PLAN COMMISSION MEETING AGENDA

TUESDAY, May 13, 2014
AT 6:00 P.M.

PROJECT: Plan Amendment – Stella and Chewy’s (“Project Red”)

DRAWING TITLE
 BUILDING ELEVATIONS
DRAWING NO.
A03-01
 Forum # 601-01445 Consult.#

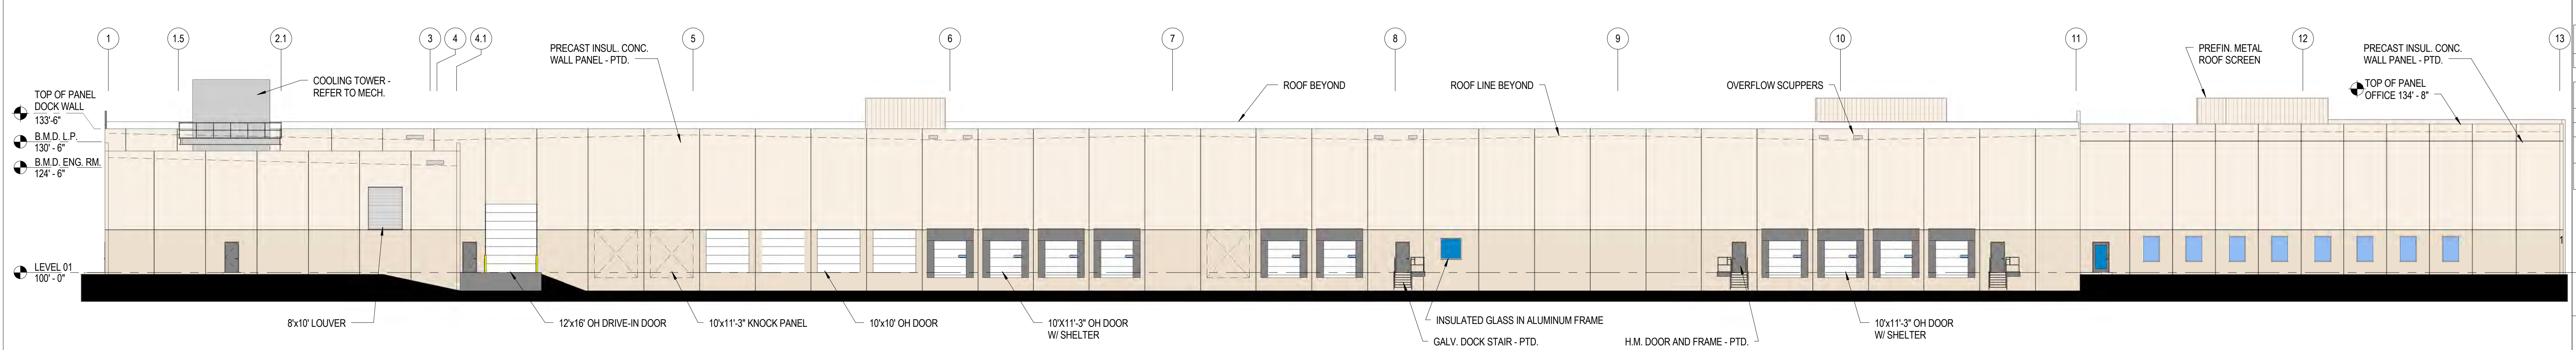
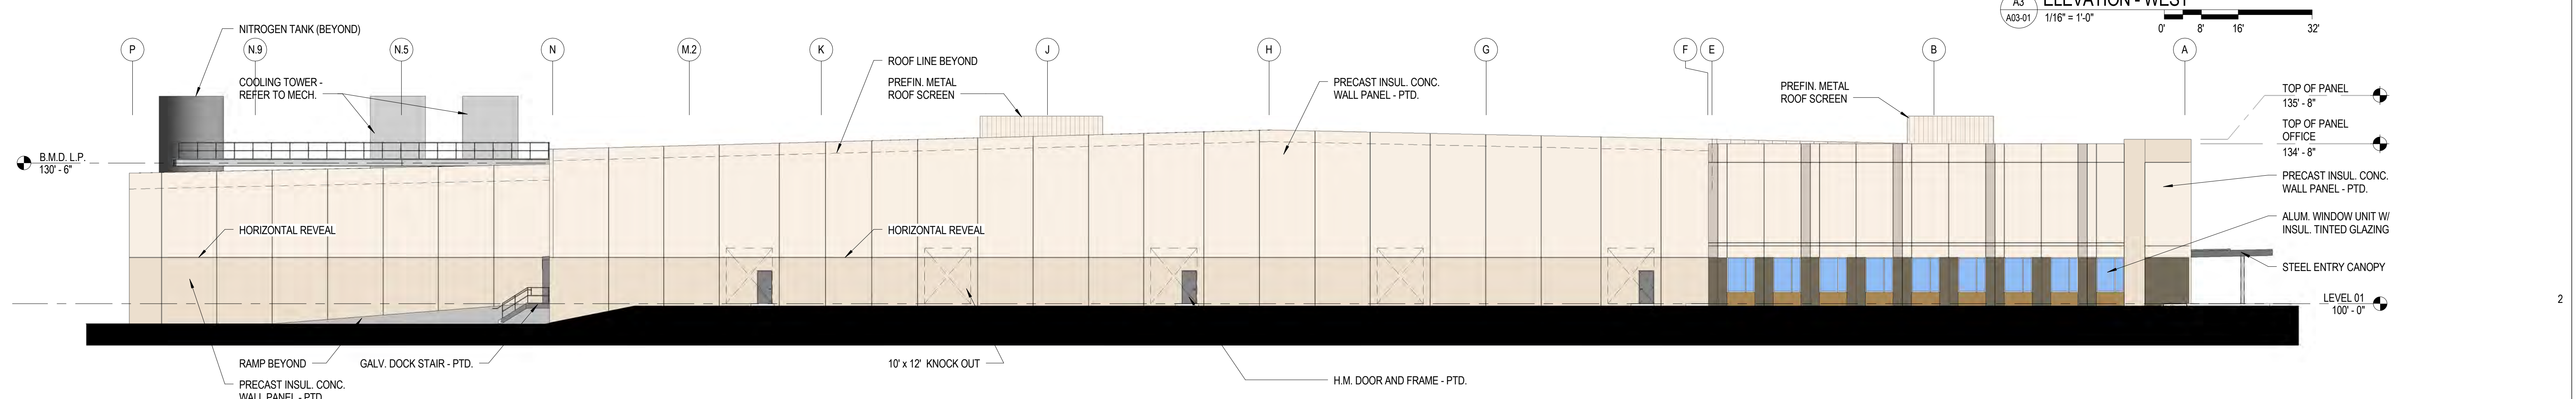
Commentary: At the Plan Commission meeting on April 22, 2014, the Plan Commission approved of site, building, and landscaping plans for the proposed manufacturing facility with office space for Stella and Chewy’s (“Project Red”). It was noted in the staff report that the east and west elevations were to be comprised primarily of insulated metal panel walls due to the refrigeration needed by the production and storage of food products, as well as the ability to expand the building to the east and west. Metal wall panels are not acceptable as a primary building material nor do they meet the visible perimeter requirements.

While this was intended to provide some flexibility for the needs of the business while still maintaining the spirit of the requirements of Chapter 17, concerns were raised for the interruption of production at such time this condition was to be met. Staff met with the Applicants to discuss an alternative plan, which is included

in your packets. The plans now depict precast concrete walls on the east elevation (along Howell Ave.) instead of the metal wall panels shown in the previously-approved plans. The insulated metal panel walls would remain on the west elevation, but proposed landscaping would limit the view from Oakview Parkway (interior to OakView Business Park). Therefore, staff has recommended approval of the revised plans.

“The prefinished metal panel walls shall be converted to a more permanent material (e.g., precast concrete) if the planned east expansion is not commenced within 5 years of the date of initial occupancy of the building.”
